Landscape Referral Response

Application Number:	DA2024/1800
Date:	17/04/2025
Proposed Development:	Construction of a sea retaining wall and use of existing sea retaining wall
Responsible Officer:	Brittany Harrison
Land to be developed (Address):	Lot 122 DP 12749 , 55 Robertson Road SCOTLAND ISLAND NSW 2105

Fig. 1 - Annotated section indicating wall height and planter size.

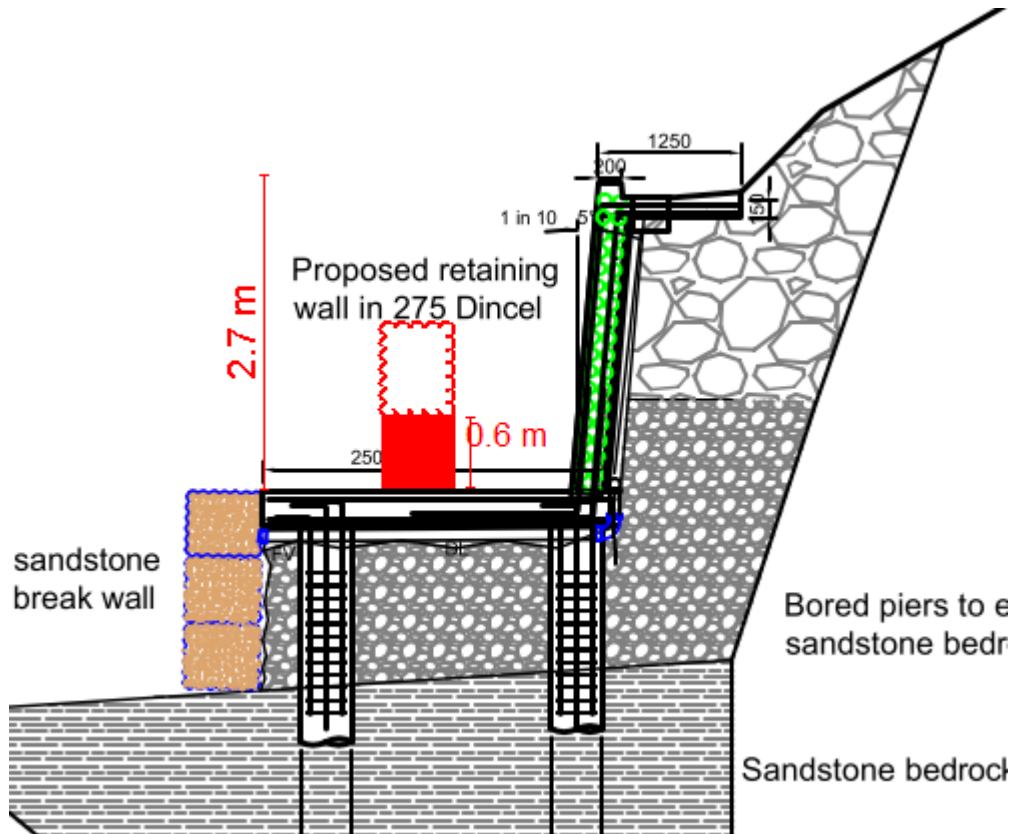
The plans provided indicate a relatively large structure above the existing sandstone wall, some 2.7m

in height and extending 4m into the slope.

No landscape plan was sighted with the documents provided, though the SEE indicates that planters 600mm wide and 600mm deep are proposed along the front of the new wall. Fig. 1 below indicates the relative scale of the wall and proposed planters. It is evident that the planters would be insufficient to provide for integration into the natural landscape and reduce visual prominence.

Further information is required detailing native planting to stabilise the slope above and below the wall with incorporation of natural materials to reflect the coastal foreshore character of the area. It is recommended that a landscape plan prepared by a qualified landscape architect be provide to address the current shortcomings of the proposal in terms of landscape integration.
